Subject: Exelon Nuclear Texas Holdings, LLC  
Victoria County Station Early Site Permit Application  
Response to Request for Additional Information Letter No. 09  
NRC Docket No. 52-042

Attached are responses to NRC staff questions included in Request for Additional Information (RAI) Letter No. 09, dated May 6, 2011, related to Early Site Permit Application (ESPA), Part 2, Sections 02.05.01 and 02.05.03. NRC RAI Letter No. 09 contained twenty-three (23) Questions. This submittal comprises a partial response to RAI Letter No. 09, and includes responses to the following eight (8) Questions:

Figure 2.5.1-50a. Fault D Topographic Cross Section (Profiles 1, 2, and 3).

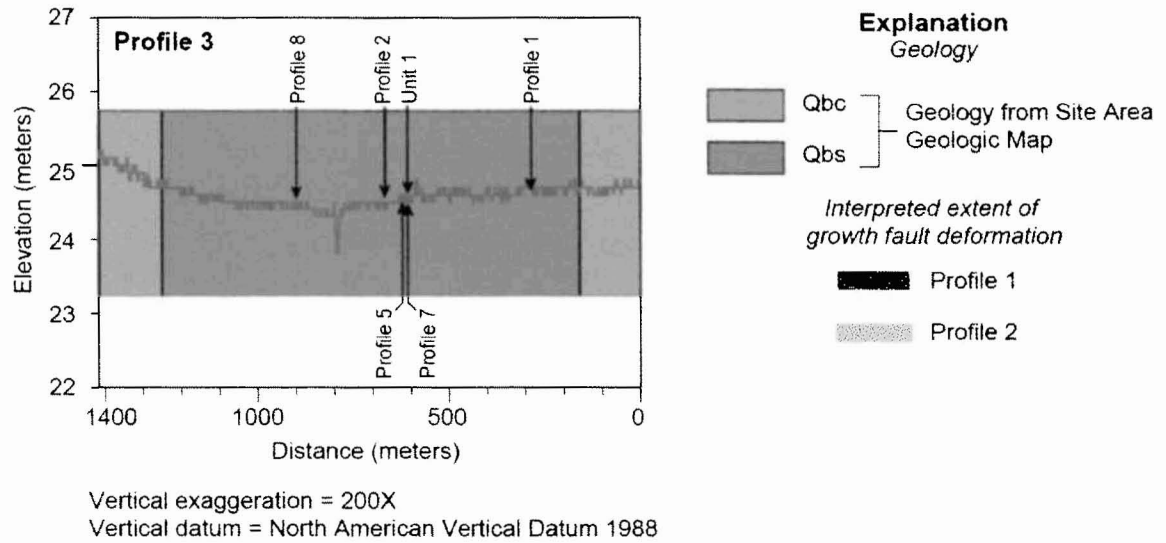
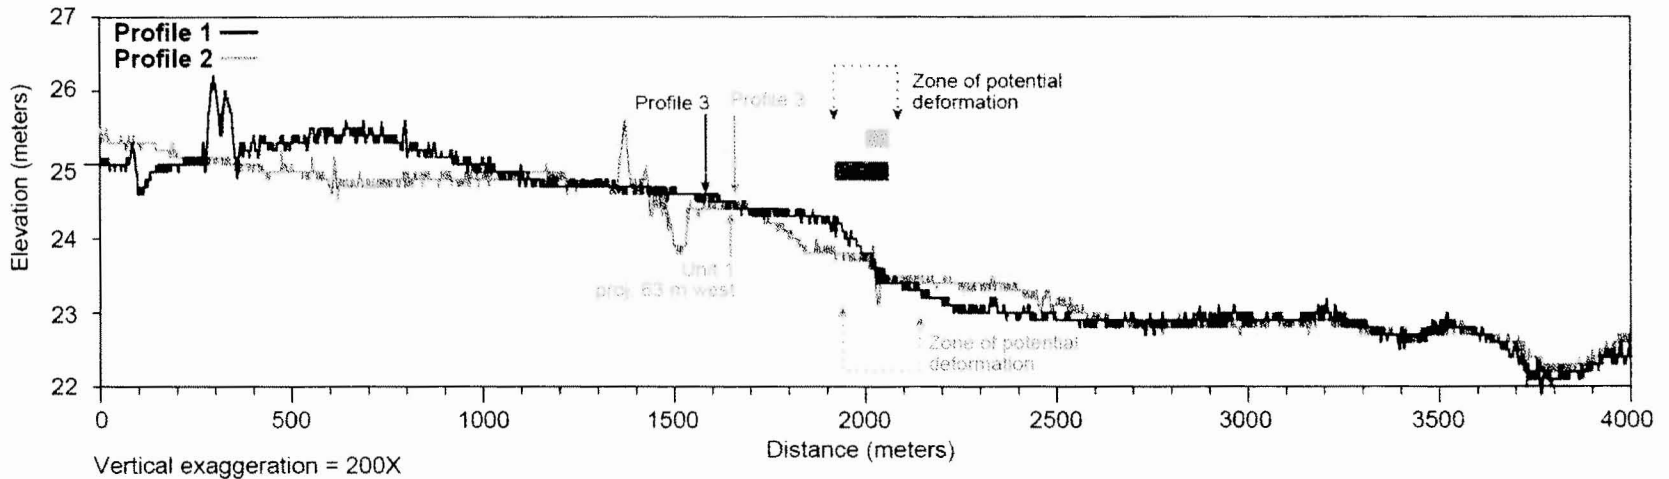
1. Please explain your justification for defining the boundary of the zone of deformation as the shaded triangle, as interpreted in the Figure 2.5.1-48, rather than the wider zone of deformation postulated above.
2. Please explain how you used the surficial topographic (LiDAR) data to define your interpreted zone of deformation. Also, please explain how the topography could be used to preclude the existence of a wider zone of deformation associated with fault D.
3. Please provide further justification for your interpretation that the lack of a topography break in LiDAR Profile 7 can be attributed to geomorphic or cultural processes rather than a wider zone of deformation between marker 1550 m southeastward to 2400 m, which encompasses the proposed location of Unit 1.

As a result of this RAI response, it was determined that the labeling of profiles 1 and profile 2 was transposed on SSAR Figure 2.5.1-50a, which resulted in several typographical errors in SSAR Subsection 2.5.1.2.4.2.3.2. SSAR Figure 2.5.1-50a has been revised as part of this response and the revisions to SSAR subsection 2.5.1.2.4.2.3.2 are provided below.

Figure 2.5.1-50a will be revised to include the vertical datum, as shown on the attached revised figure.
